BEFORE THE HUTT CITY COUNCIL

IN THE MATTER of the Proposed Lower Hutt District Plan

STATEMENT OF REBUTTAL EVIDENCE OF SEAN BELLAMY

Hearing Stream 4 – Quarry Zone and Other Zones

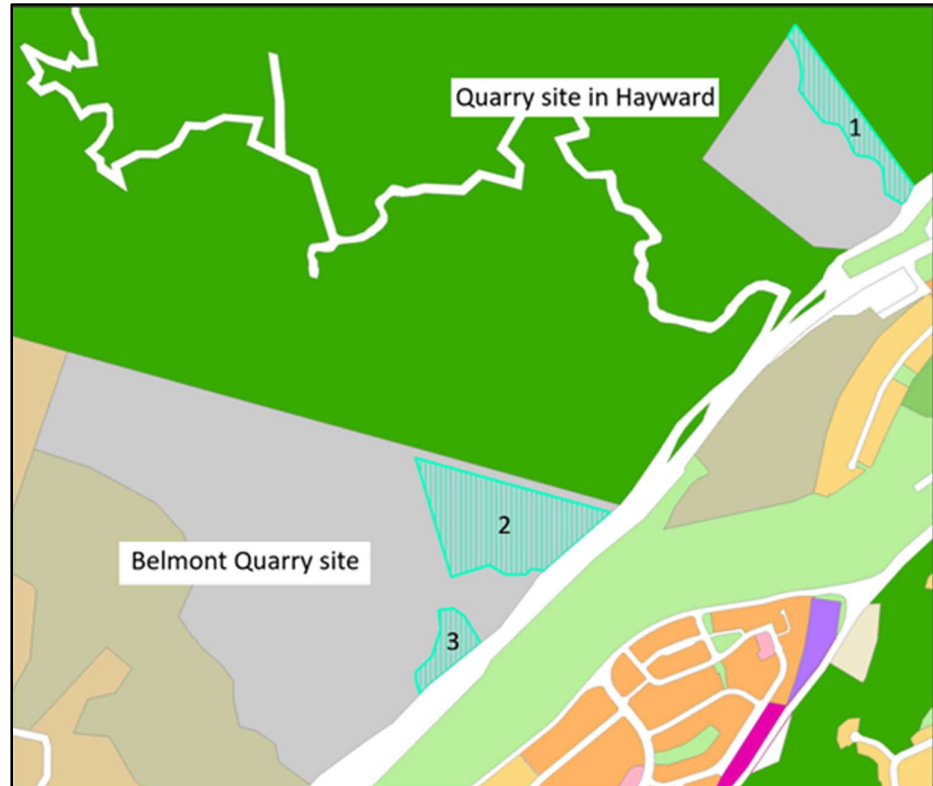
4.34 Mr Compton-Moen advises that that a targeted exemption from QUARZ-S1 is appropriate from a visual effects perspective, provided it is limited to quarry operational structures that are:

1. Ancillary to quarrying activities or quarry processing;
2. Located within the existing quarry floor, processing area, stockpile area, or yard;
3. Not located on ridgelines or external faces where they would be read as prominent skyline elements from outside the Quarry Zone; and
4. Designed and finished in a recessive or utilitarian manner consistent with quarry plant and structures.

4.35 Ms Armstrong has reviewed Mr Compton-Moen's evidence, and recommends the retention of QUARZ-S1 on the basis that there is potential for structures to compromise visual and landscape values associated with the skyline.

4.36 I agree with Ms Armstrong's assessment and consider that the standard QUARZ-S1 provides an appropriate consenting pathway for structures in the Quarry Zone. The matters of discretion also provide for consideration of the functional need or operational need for the structures, while considering visual effects. Accordingly, I do not recommend any amendments to QUARZ-S1.
